Kingscroft Farm, Havant: TA Additional Addendum

Ref: TW/BB/ITB15443-008B TN
Date: 25 June 2024

Image 2.1: Proposed Site Access Arrangements – Forward Visibility

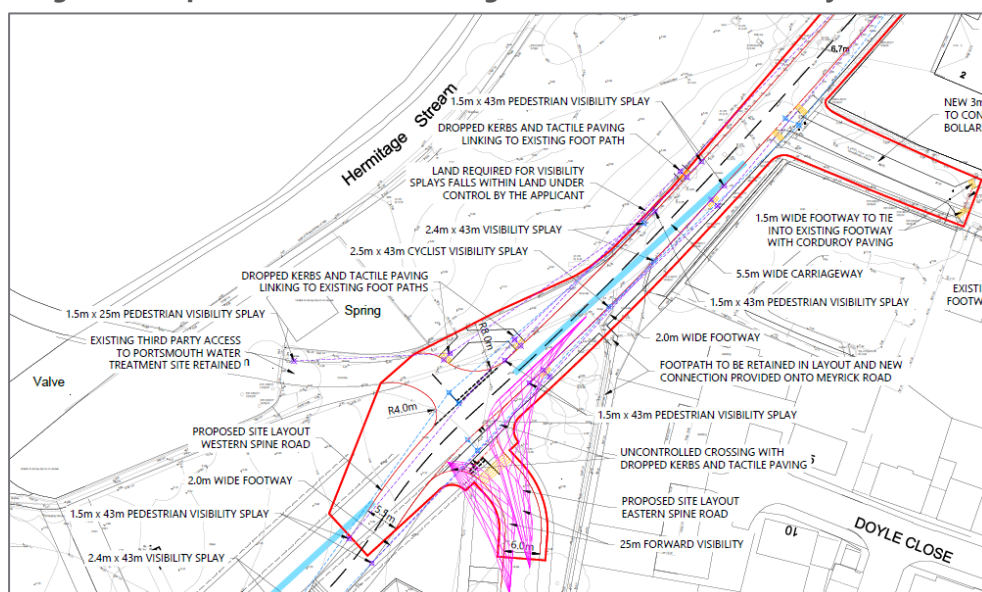
- 2.2.1 HCC raised three specific matters relating to the design of the proposed site access arrangements:
 - 1 The stagger distance between the proposed Portsmouth Water access and the first access into the development would require a departure from standard.
 - 2 Forward visibility in accordance with a 20mph design speed (25m) needs to be provided on the inside of the bend in the first access junction into the development.

- 2.2.5 The site access design has been updated to include a 25m forward visibility splay around the inside of the first site side-road junction. The updated drawing is shown as i-Transport drawing no. **ITB15443-GA-001M**, an extract of which is shown as **Image 2.1**.

Image 2.3: Illustration of Excessive Carriageway Widening Required to Ease Vehicle Tracking

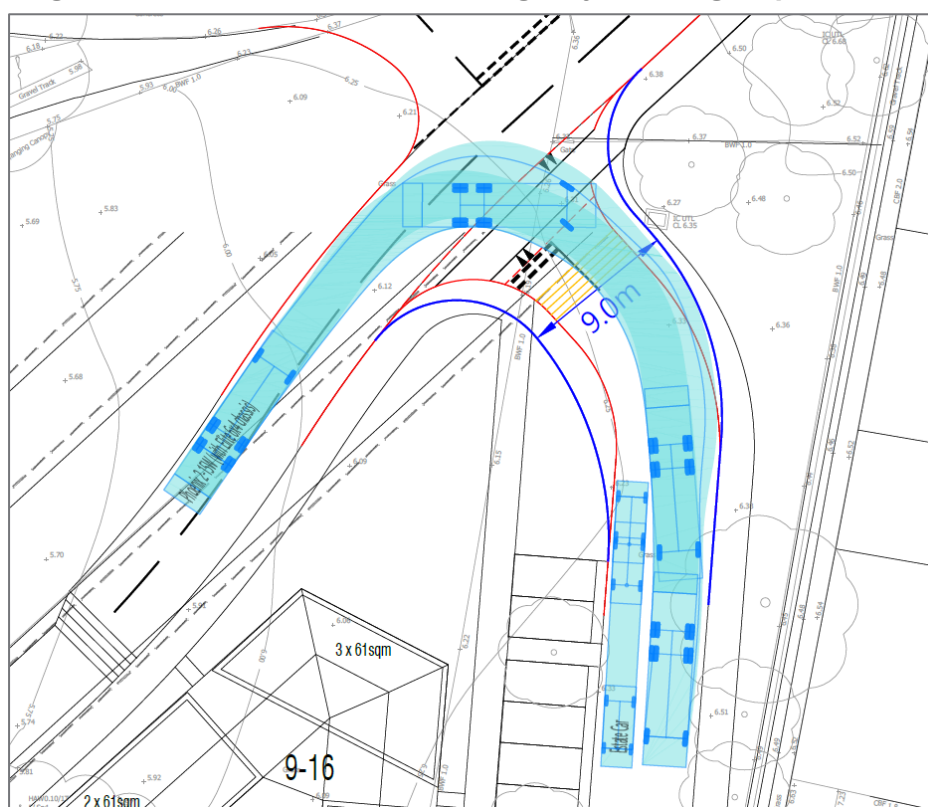
- 3 A refuse vehicle and fire tender rely on the opposite side of the carriageway to access the first access junction into the development. The radius of the junction needs to be amended to ease these movements (particularly the right-turning movement) and improve vehicle tracking.

2.2.9 Whilst it is necessary for the refuse vehicle and fire tender to utilise both sides of the roads when accessing/egressing the junction, this is commonplace at residential junctions and is permitted by the guidance in Paragraph 3.2.12 of HCC TG2 provided there is adequate forward visibility at the junction. In this instance, adequate forward visibility is provided, demonstrated on Drawing **ITB15443-GA-001M**.

2.2.10 With reference to the above, there is no need to amend the design further to accommodate for the movements of the weekly refuse collection vehicle or emergency vehicles. To do so (**Image 2.3**) would be contrary to HCC guidance in TG2 and would require significant widening of the carriageway (to c. 9.0m), resulting in an arrangement that would be inappropriate for a residential environment, would encourage higher vehicle speeds and would be poor for pedestrian use. This matter has also been discussed and agreed separately with HCC (**Appendix B**).

Image 2.5: Ranelagh Road 'fallback' Position

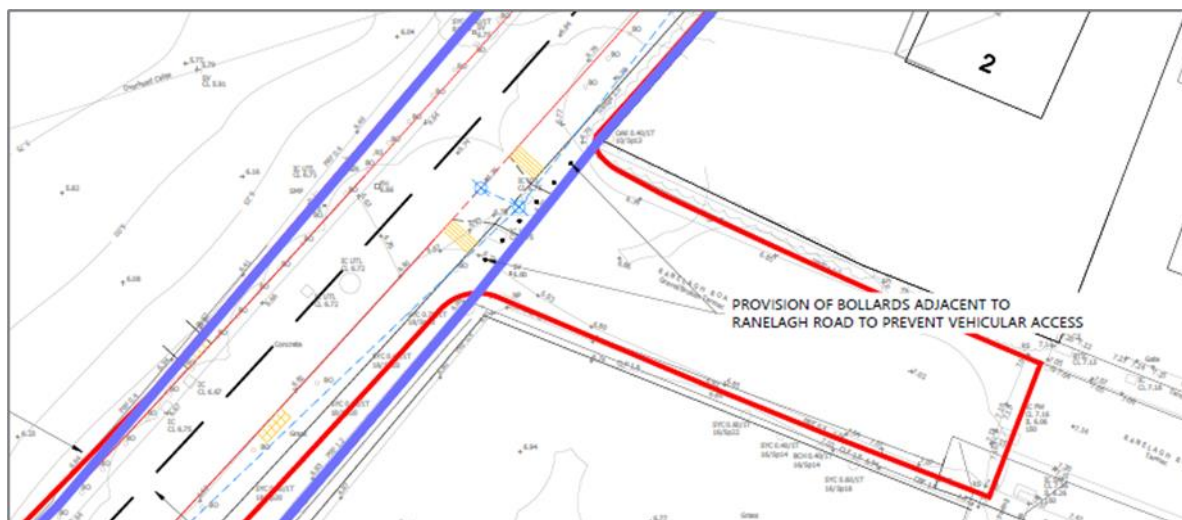
2.4.4 The applicant remains committed to proceeding with the Section 228 process to ensure that the proposed S278 highway improvements can be delivered onto Ranelagh Road. The scope of the works to Ranelagh Road are agreed with HCC. However, the Section 228 process is separate to the planning process and therefore its outcome cannot be assured.

- 2.4.6 The alternative Ranelagh Road 'fallback' position is shown on i-Transport drawing no. **ITB15443-GA-021**, an extract of which is shown as **Image 2.5**. This comprises the provision of bollard restrictions across Ranelagh Road to prohibit vehicular access, located within the Portsmouth Water Title and would have the effect of providing an ongoing active travel connection, but without relying on works to the unregistered section of the road.

2.4.7 The 'fallback' option achieves the key aims of the s228 scheme in that:

- i The closure of Ranelagh Road to vehicle traffic – through the implementation of bollards on land which is within PW's ownership.
- ii The continued access along Ranelagh Road for non-motorised users – again, through the implementation of bollards on land which is within PW's ownership.
